**SUBJECT:** NuScale Power, LLC Supplemental Response to NRC Request for Additional Information No. 134 (eRAI No. 8934) on the NuScale Design Certification Application

## Response to Request for Additional Information Docket No. 52-048

**NRC Question No.:** 03.07.02-15

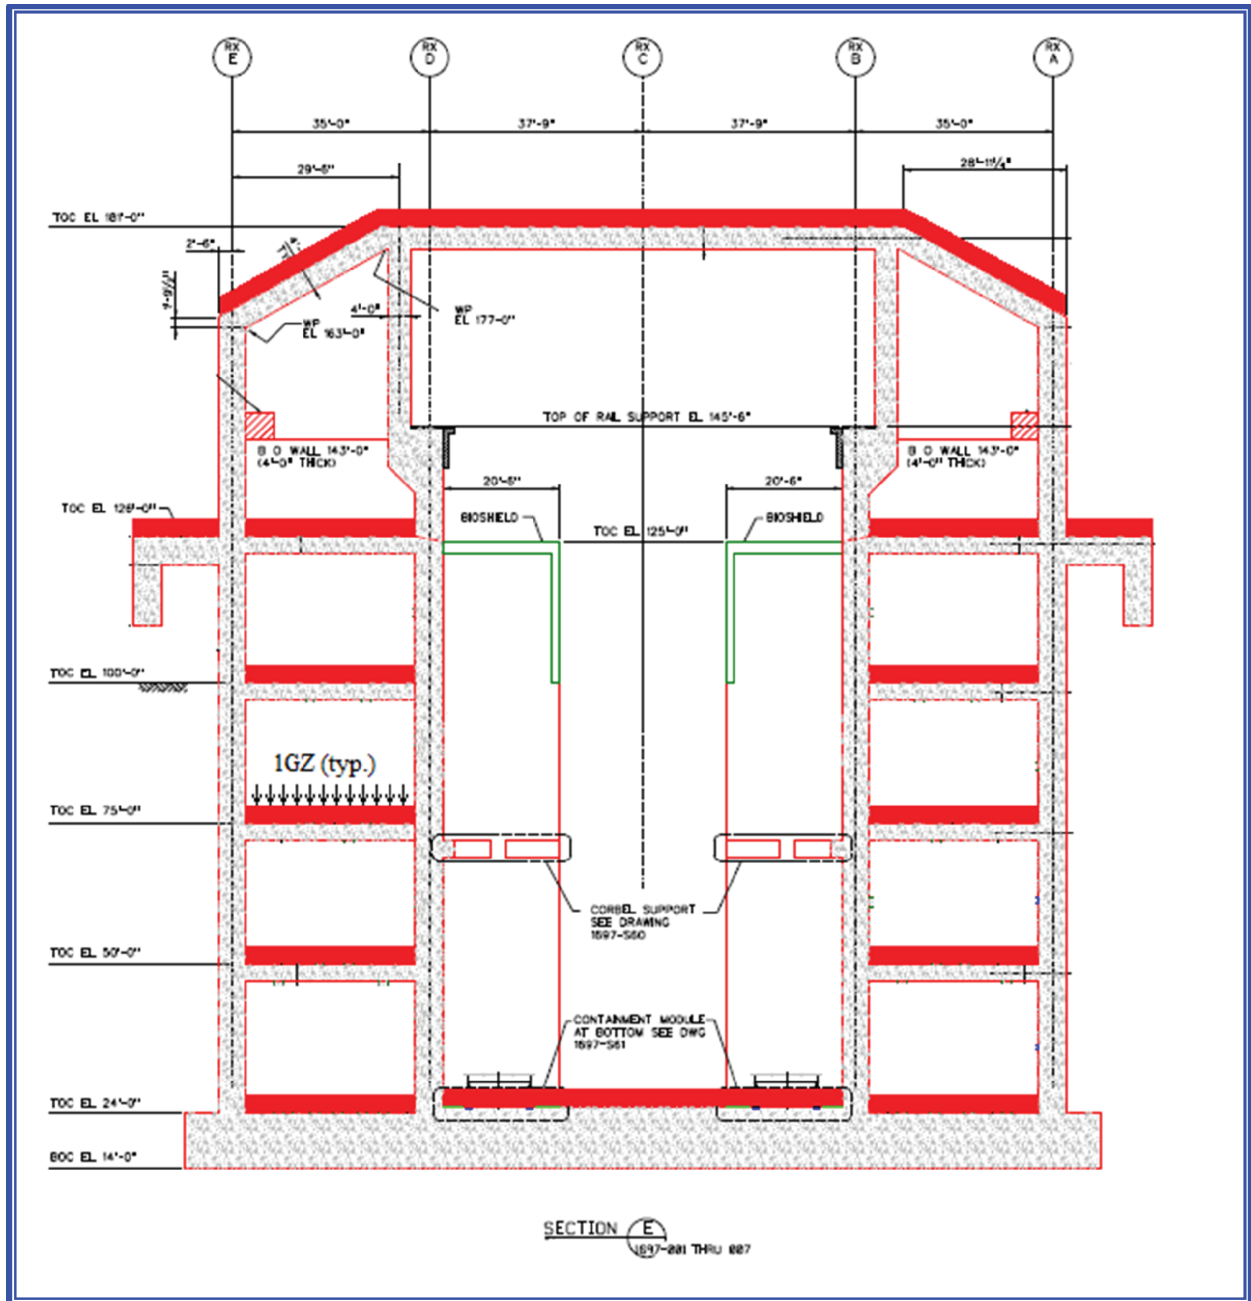
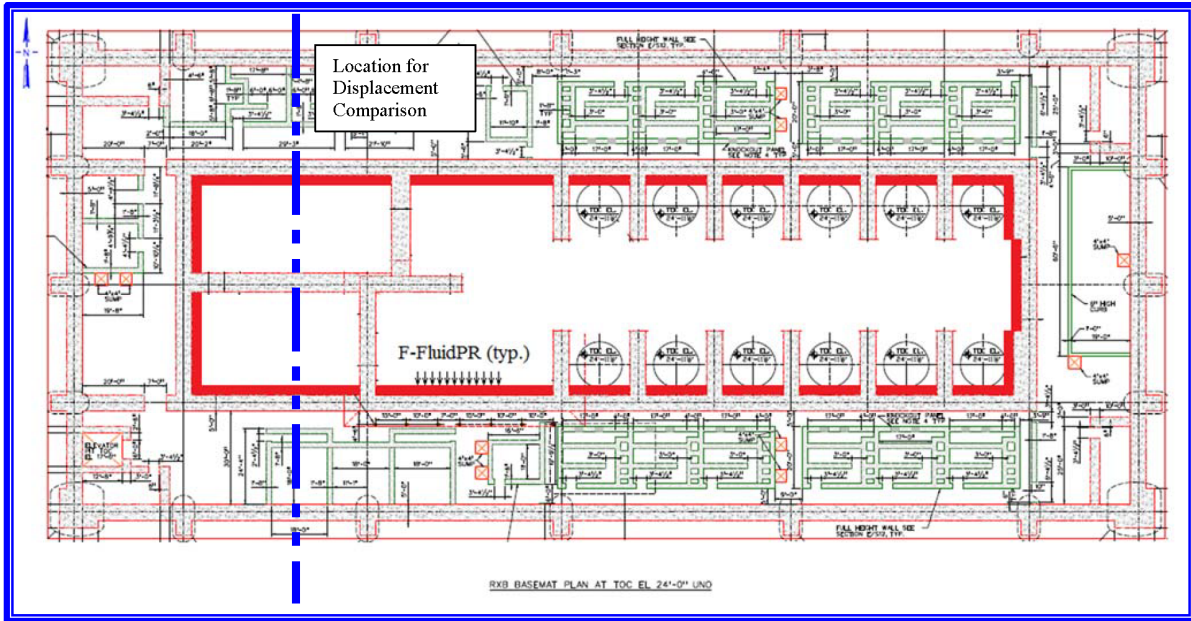
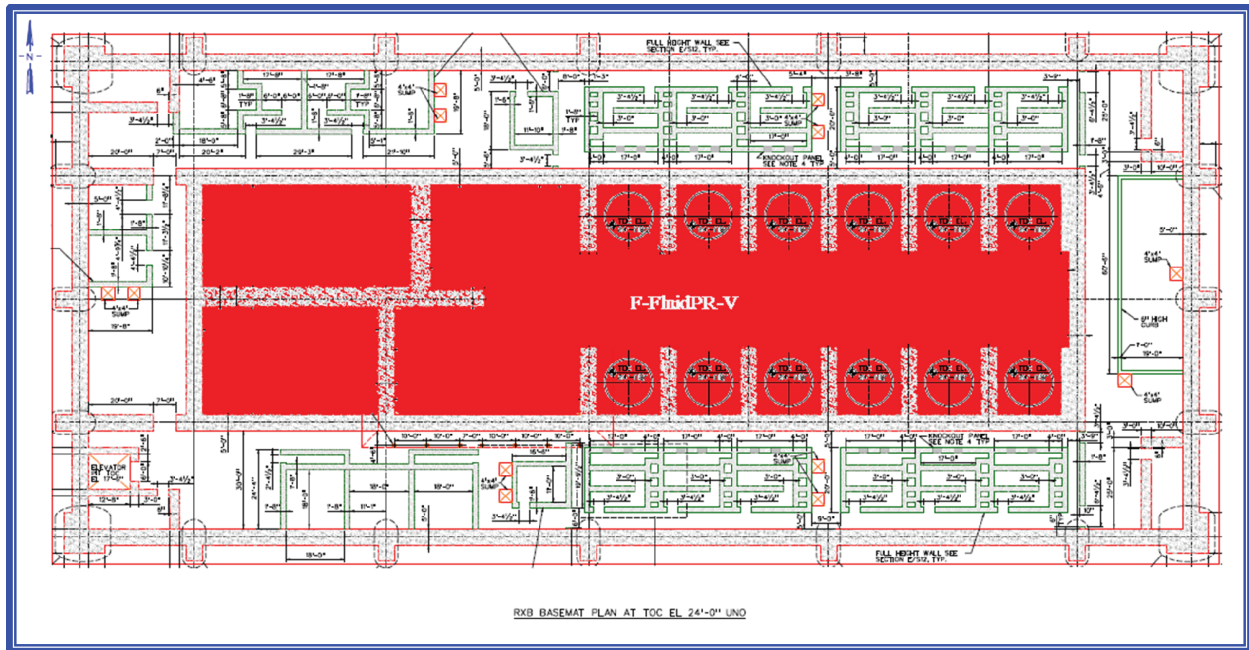
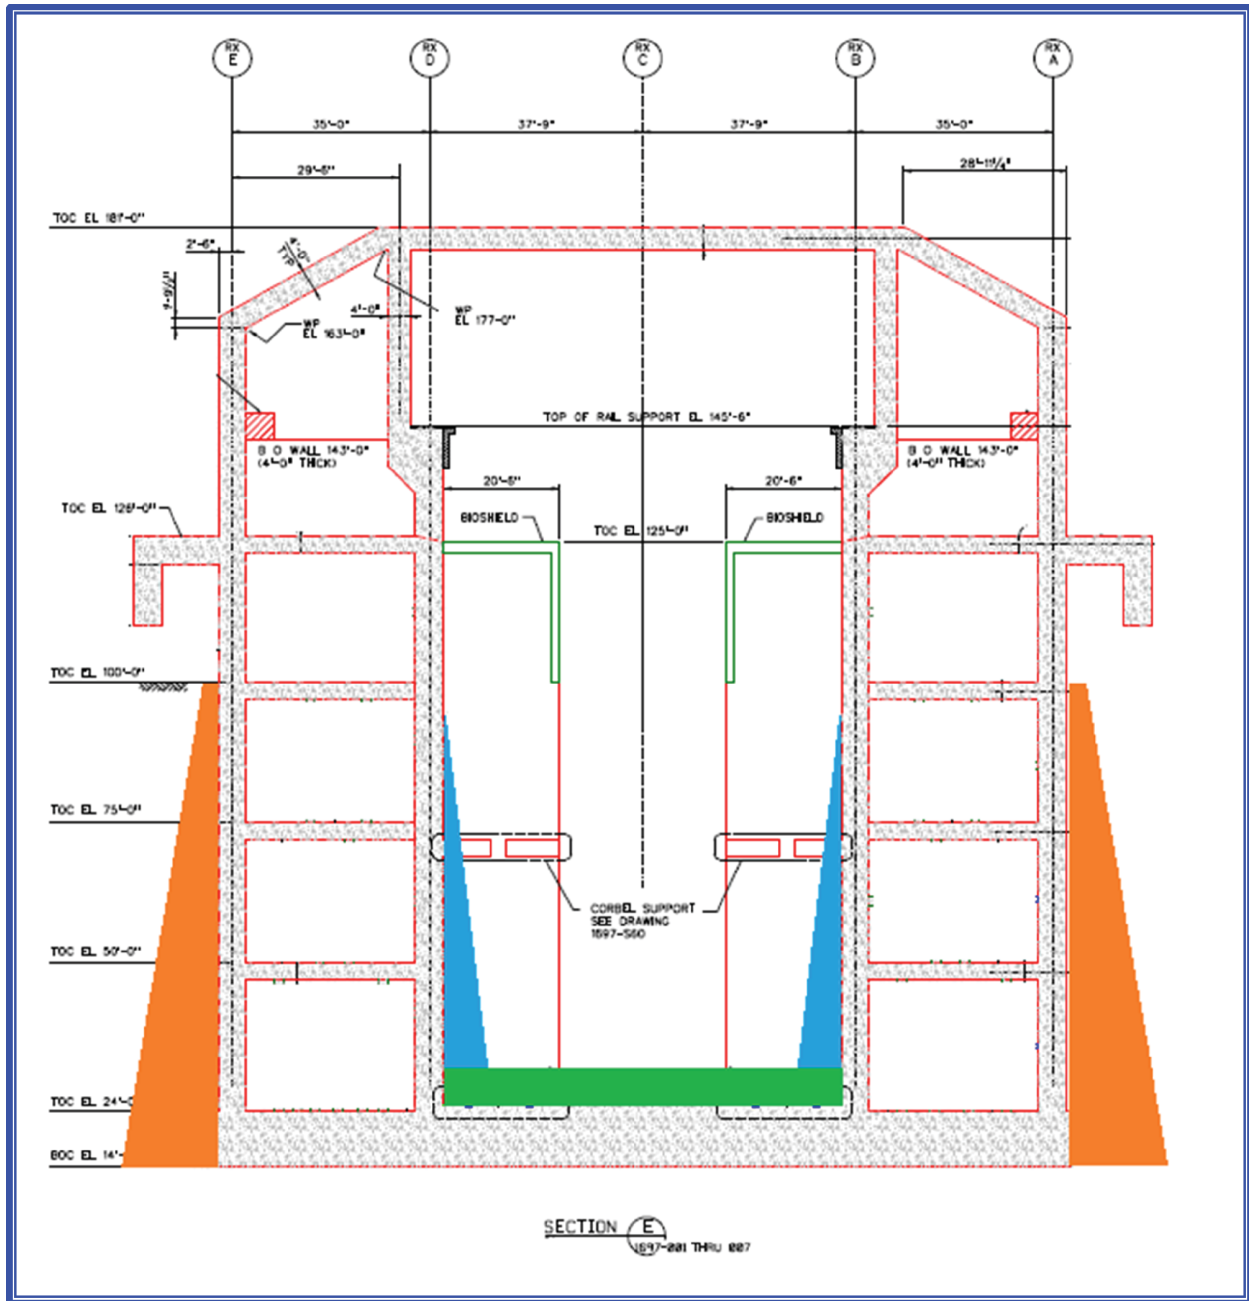
1. FSAR Eq. 3.7-14 (Page 3.7-118, Revision 1) represents the corrected equivalent static pressure due to hydrodynamic effects (including 3D FSI). The applicant derived "missing" FSI pressure as difference between pressures obtained from Eq 3.7-14 and from the original SASSI2010 lumped-mass analysis. In implementing the missing FSI pressure in SAP2000, the applicant did not apply an actual pressure profile (i.e., pressure differential between Eq 3.7-14 and original SASSI2010). Instead, the applicant chose to amplify the gravity load by a factor of 1.28 in order to add missing FSI pressure loading to the SAP2000 model. The staff's concern is whether the use of a gravity load factor will result in an equivalent or conservative design demand compared to the use of an actual pressure profile.

Therefore, the applicant is requested to provide figures or tables that compare pressure profiles on the pool walls and foundation obtained from the actual missing FSI pressure and from amplifying the gravity load by a factor of 1.28. If significant differences are identified in such comparison, the applicant should provide an evaluation demonstrating that the use of a gravity load factor of 1.28 results in an incremental design demand (forces, moments, deformations, etc.) that would have bound the increased demand should the applicant have used the actual pressure profile accounting for the missing FSI effect in SAP2000, for both the RXB pool walls and foundation.

Response: NuScale has performed analyses that confirm that the 1.28 x gravity load bounds a 4.2psi pressure profile and is providing these results as part of this response.

Figure 1-1 shows a cross-sectional elevation view of the RXB and the inertial loading in the vertical direction. Figure 1-2 shows a cross-sectional plan view of the RXB and the fluid pressure loading in the horizontal direction. Figure 1-3 shows a cross-sectional plan view of the RXB and the fluid pressure loading in the vertical direction. Figure 1-4 shows a cross-sectional elevation view of the RXB with the combined soil pressure and fluid pressure for the static portion of ACI Equation 9-6.
